Planning App Ref:	PL/2026/02266
Service Ref:	Drainage
Date:	18/08/2026

Full planning permission for erection of 9 residential dwellings, access, parking, gardens, landscaping and associated works.

Land south of, Park Street, Warminster

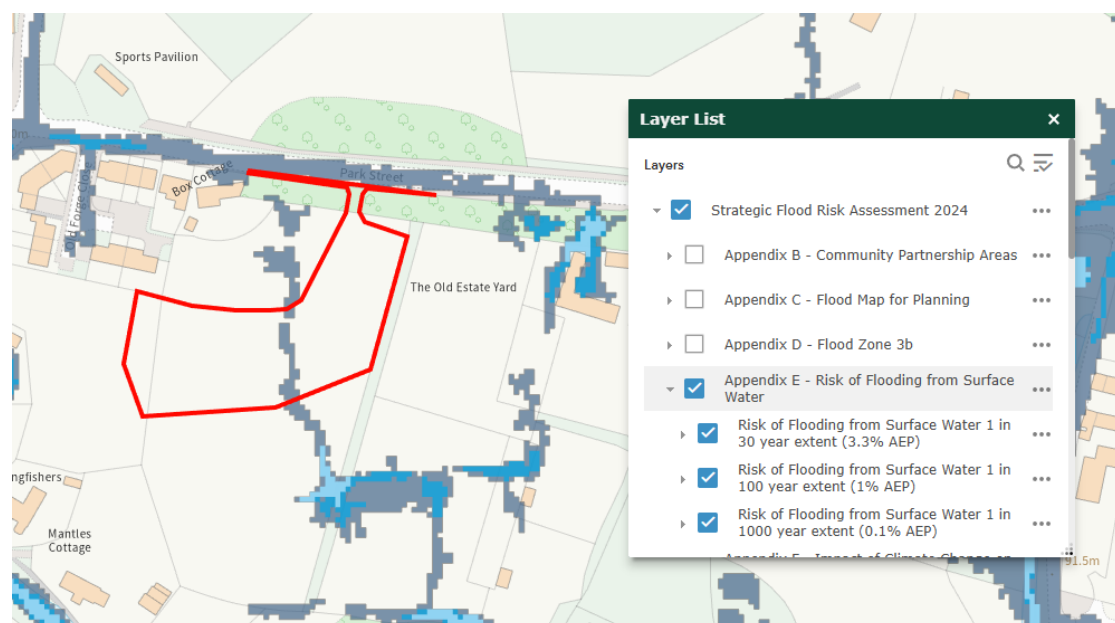
The Wiltshire Council Strategic Flood Risk Assessment, [SFRA Data Explorer](#), has indicated that the site is located within Flood Zone 1 and has a low level of risk from fluvial flooding. The site has a low level of risk from surface water flooding and there is small portion at centre of the site and the access road located in front of the site falling within the 1 in 100-year flood extent.

SFRA mapping identifies the site as having a medium risk of groundwater flooding.
